Unbalance

Rev. 3

MICHAEL PAUL

Figure 145–22—PSE PI unbalance specification and system resistance unbalance

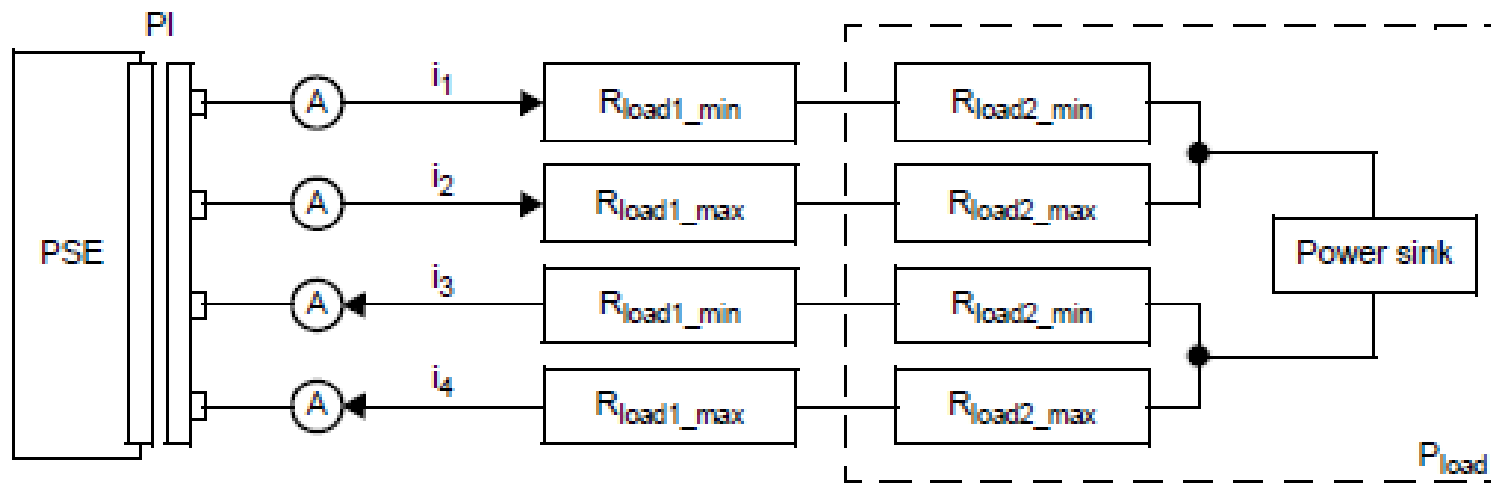
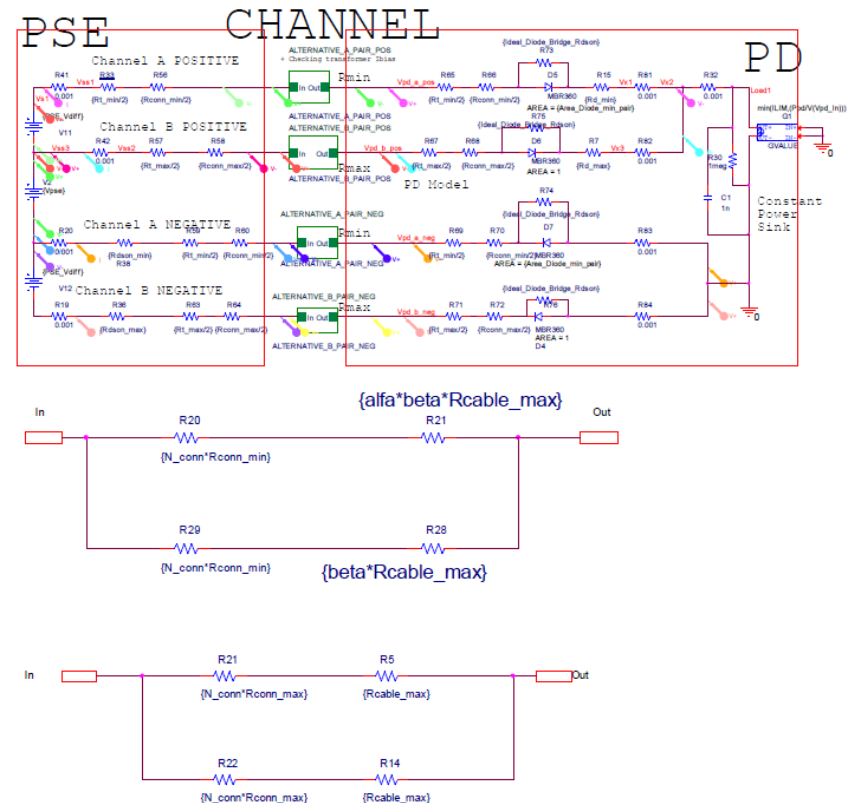
- ▶ Draft 3.1 $I_{\text{Unbalance-2p}}$ was changed to 560mA to provide margin.
 - Now, using the PSE test from table 145-18, $R_{\text{PSE_alpha}}$ can be changed to 2.67 and pass the compliance test
 - That is the PSE can be more unbalanced and pass the hardware compliance test

- ▶ Plugging $R_{PSE_alpha} = 2.67$ back into the System Unbalance model gives $I_{con-2p,max} = 571mA$
- ▶ This PSE passes the compliance test but may fail to interoperate

► We need two unbalance numbers

- $I_{\text{Unbalance-2p}}$ for the hardware unbalance test (component unbalance contribution)
- $I_{\text{Con-2p-unb}}$ for the system at runtime (software-controlled current threshold)
- The hardware test limit must be less than the runtime unbalance limit to ensure margin
